<b>Panel Reference</b>	<b>PPSSSH-90</b>
<b>DA Number</b>	DA2021/0306
<b>LGA</b>	Georges River Council
<b>Proposed Development</b>	Demolition works, lot consolidation and construction of a three storey residential flat building comprising of 30 units, basement carpark and landscaping works.
<b>Street Address</b>	43-49 Gover Street, Peakhurst
<b>Applicant/Owner</b>	Applicant: NSW Land and Housing Corporation Owner: NSW Land and Housing Corporation
<b>Date of DA lodgement</b>	23 August 2021
<b>Number of Submissions</b>	Two submissions
<b>Recommendation</b>	Approval subject to conditions of consent.
<b>Regional Development Criteria (Schedule 6)</b>	<p>Regionally significant development is defined in Schedule 6 of State Environmental Planning Policy (Planning Systems) 2021.</p> <p>The proposed development is classified as “Regional” development as it has a Capital Investment Value (CIV) of over \$5 million and is lodged by or on behalf of the Crown (State of NSW).</p> <p>The CIV of the project is \$9,984,927.00.</p>

<ul style="list-style-type: none"> <li>• Hurstville Local Environmental Plan 2012</li> <li>• Hurstville Development Control Plan No.1 (Amendment 6)</li> <li>• Georges River

Figure 10 Height blanket diagram showing height non-compliance

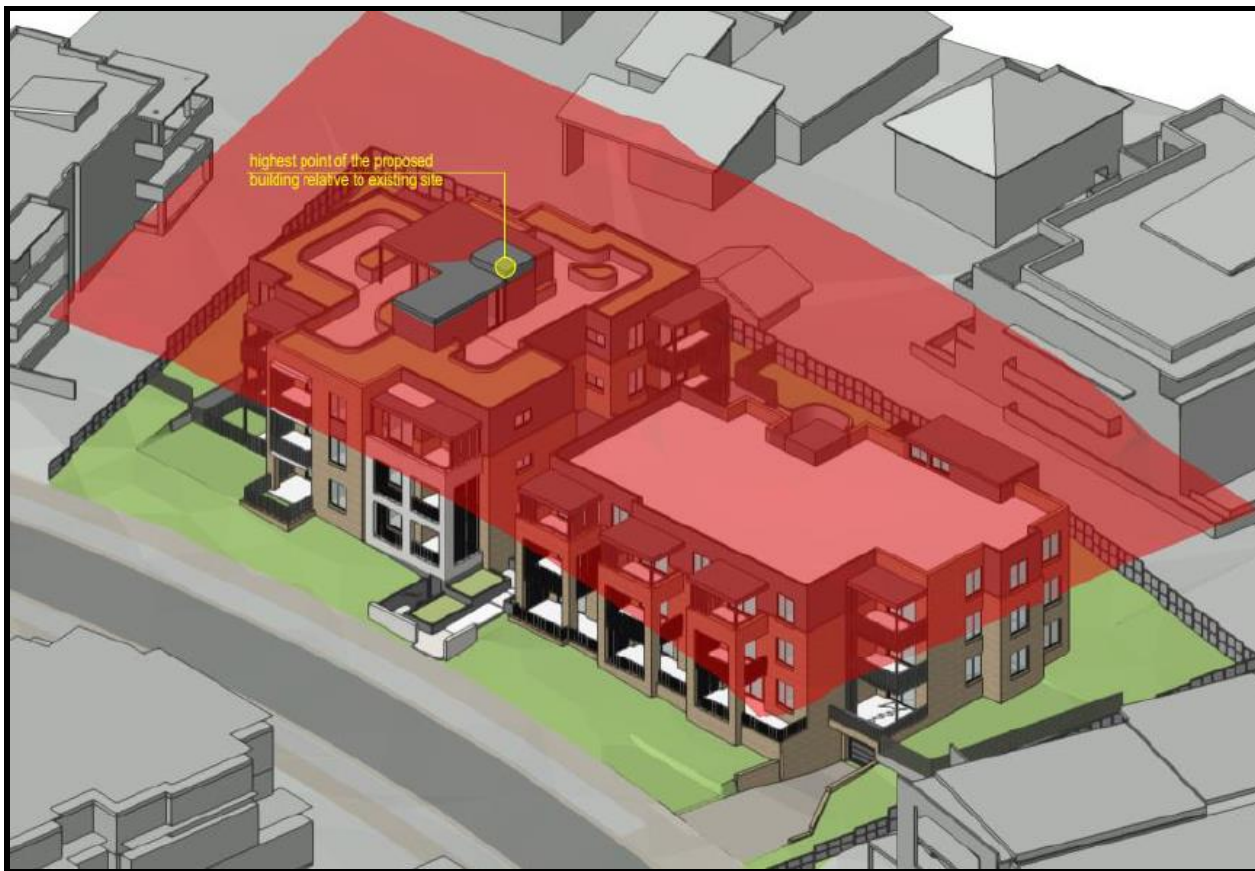
The proposed development seeks a variation to the development standard relating to height (Clause 4.3). The Hurstville Local Environmental Plan 2012 (HLEP) identifies a maximum height of 12m for the Site and the proposed development will exceed the height by up to 0.844m which comprises the lift overrun and the upper section of the stairway overrun. The remainder of the building is below the 12m height limit. This height breach amounts to a 7% variation of the control.

Any variation to a statutory control can only be considered under Clause 4.6 – Exceptions to Development Standards of the HLEP. An assessment of the proposed height against the survey plan levels was conducted to indicate the Applicant's calculations are generally accurate.

Having regard to Clause 4.6(3)(b) and the need to demonstrate that there are sufficient environmental planning grounds to justify contravening the development standard, it is considered that there is an absence of any negative impacts of the proposed non-compliance on the environmental quality of the locality and amenity of adjoining properties in terms of overshadowing, overlooking or view loss.
